Snouffer School Road North (Webb Tract)

Part E: Lois Y. Green Farm Conservation Park, Amended Forest Conservation Plan, SC2008018

Completed: 5/16/16

Re: Tree Removal Variance for Lois Y. Green Farm Conservation Park
Forest Conservation Plan SC#2008018 Amendment

Variance Tree Locations

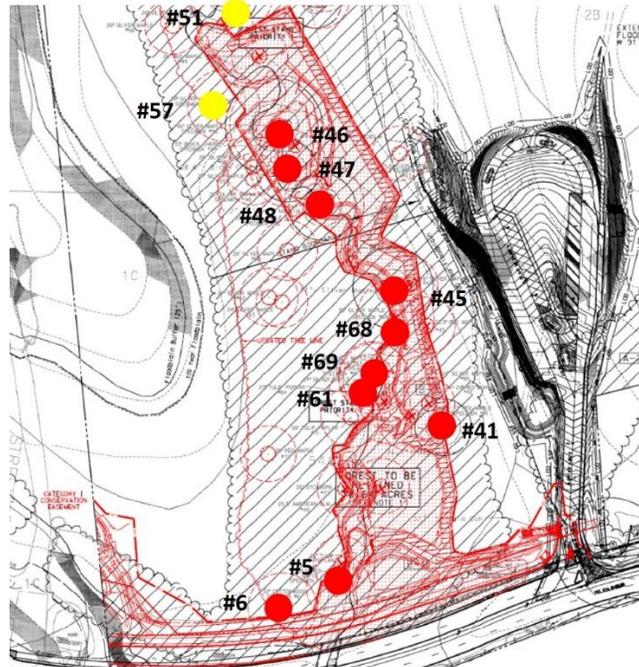
On February 2, 2016, the Applicant submitted a variance request for the increased impacts to high priority trees (revised on March 14, 2016 and again on April 12, 2016), to remove 10 trees, and impact, but retain, two trees that are considered high priority for retention under Section 22A-12 (b) (3) of the County Forest Conservation Law (Attachment 4).

ID	Species	Size	Condition	Notes
5	Silver maple	30.1"	Fair	Bridge construction and stream restoration.
6	Cottonwood	32.0"	Fair	Road widening.
41	Red maple	33.0"	Good	Access for stream restoration.
45	Silver maple	37"	Good	Stream restoration and access.
46	Silver maple	46"	Excellent	Stream restoration.
47	Black cherry	33"	Poor	Stream restoration.
48	Silver maple	36"	Good	Stream restoration.
61	Tulip poplar	33"	Good	Stream restoration.
68	Silver maple	36"	Excellent	Stream restoration.
69	Silver maple	32"	Good	Stream restoration.

ID	Species	Size	Condition	Notes
51	Silver maple	42"	Good	Stream restoration and access.
57	Silver maple	34"	Fair	Stream restoration.

Variance Findings - Based on the review of the variance request and the proposed Amended Forest Conservation Plan, staff makes the following findings:

Mitigation for Trees Subject to the Variance Provisions – Generally, mitigation is recommended for trees removed but not for trees impacted but retained. The proposed removal of ten trees will be mitigated by additional plantings. Mitigation planting is calculated at the rate of 1 caliper inch planted per 4-inch DBH lost. Using this ratio, the Applicant will be required to plant a total of 87 caliper inches of native canopy trees as mitigation for the tree variance impacts on the Site within one calendar year or two growing seasons after completion of road construction. The trees must be a minimum of three-inch caliper each.

Variance Recommendation – Staff recommends the variance be granted.

**STREAM RESTORATION
LANDSCAPE PLAN
SHEET 1**

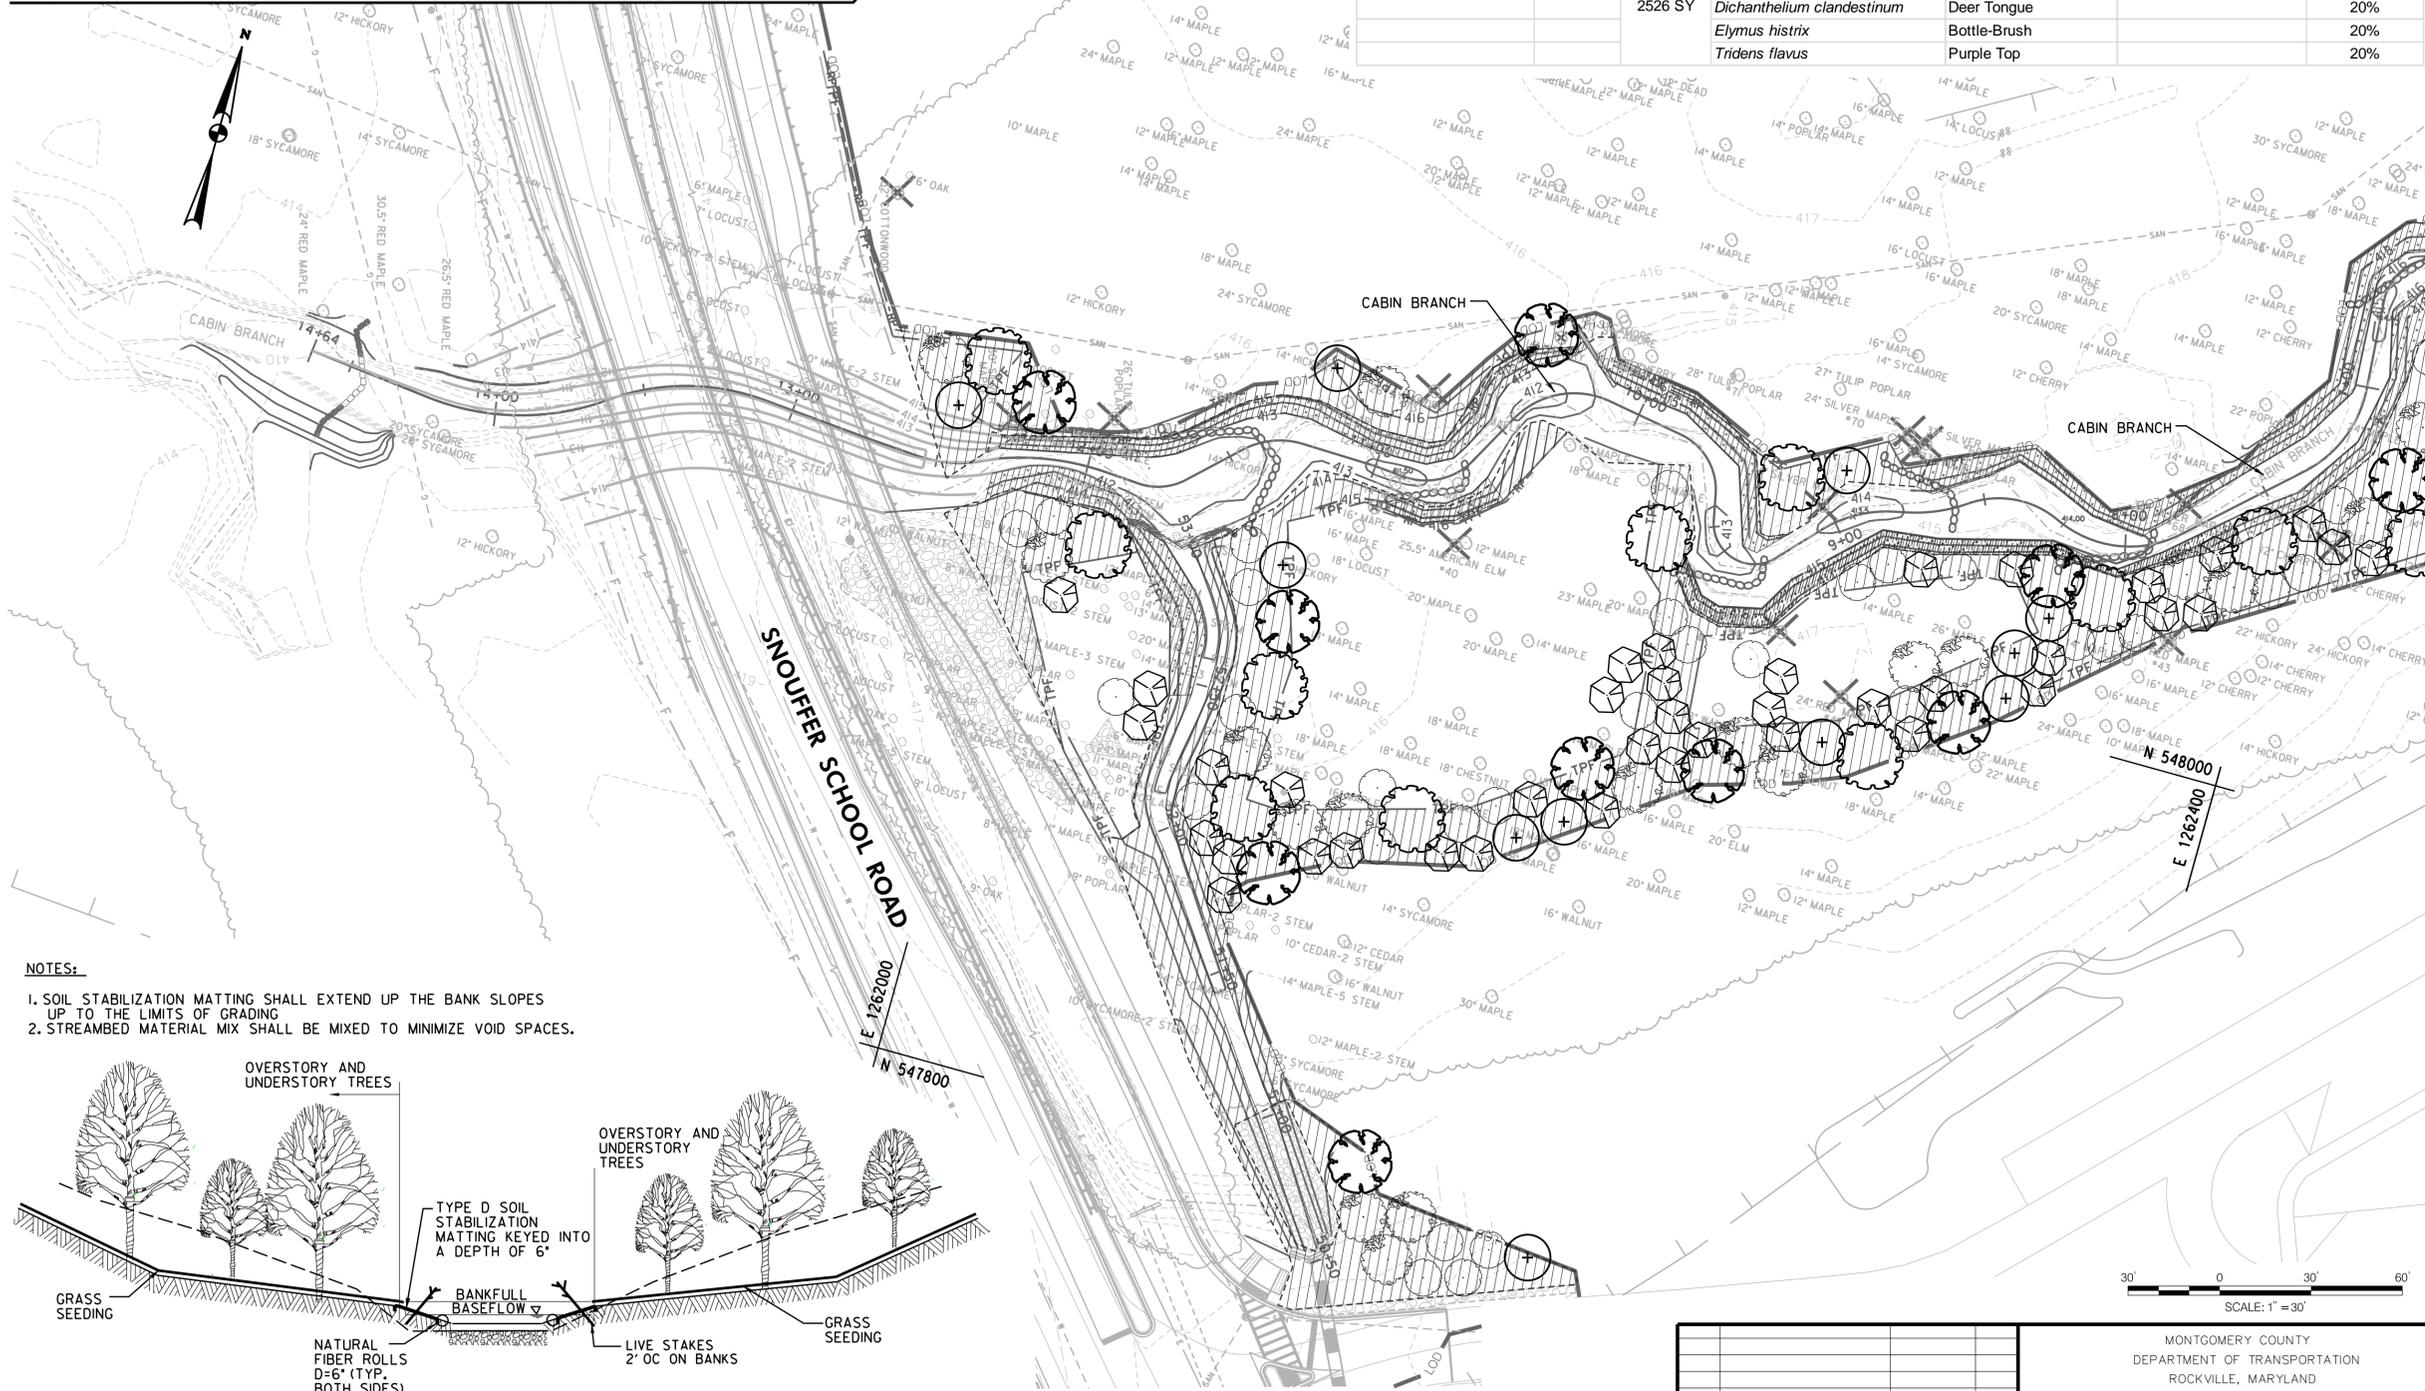
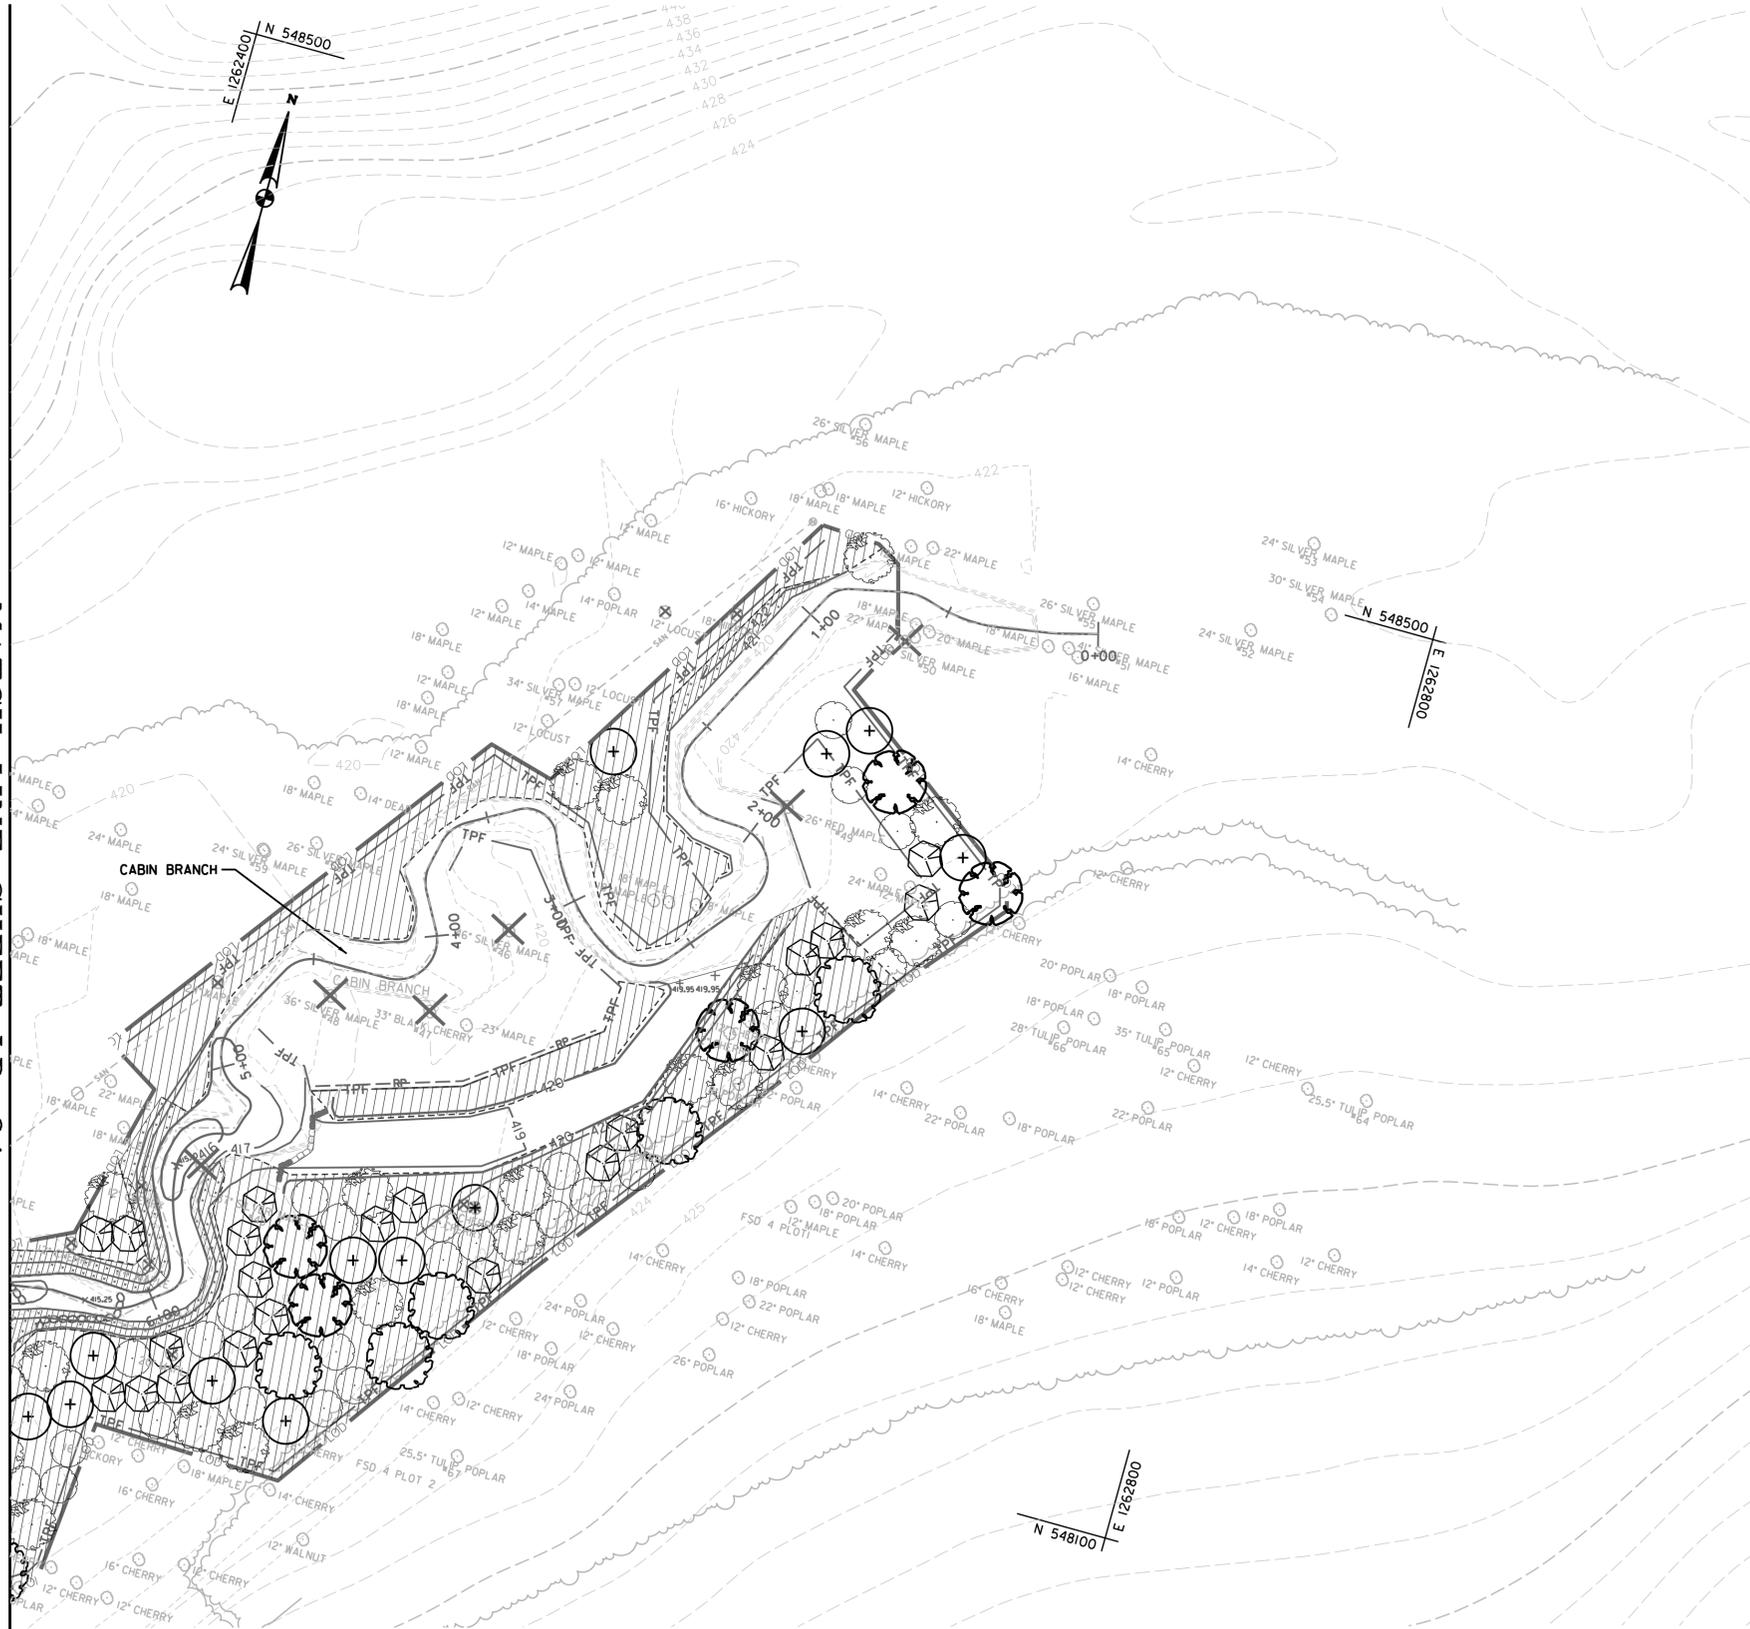
The amended FFCP shows the clearing of 2.8 acres of forest that was previously approved as retained. Although the Property will still have approximately 8.45 acres of forest retention above the break-even point (a level of forest retention that does not require reforestation), the Planning Board has consistently required mitigation plantings for the loss of forest previously approved as retained or protected by conservation easements. In order to be consistent with this policy, Staff is recommending that the Applicant must either plant 2.8 acres of forest on-site or plant a minimum of 5.6 acres of forest

off-site. The Applicant has submitted a planting plan showing individual trees with this amendment. However, the amended FFCP must be revised to reflect the requirements of COMCOR 22A.00.01.09, to show appropriate acreages of forest planting.

1. Prior to demolition, clearing, or grading, the Applicant must revise the amended Final Forest Conservation Plan to reflect all requirements of COMCOR 22A.00.01.09.
2. The Applicant must plant a minimum total of 87 caliper inches of native canopy trees as mitigation for the tree variance impacts on the Property within one calendar year or two growing seasons after completion of road construction. The trees must be a minimum of three-inch caliper each.
3. The Final Forest Conservation Plan must show how the 2.80-acre reforestation requirement will be met.
4. The Sediment Control Plan must be consistent with the limits of disturbance shown on the amended Final Forest Conservation Plan.
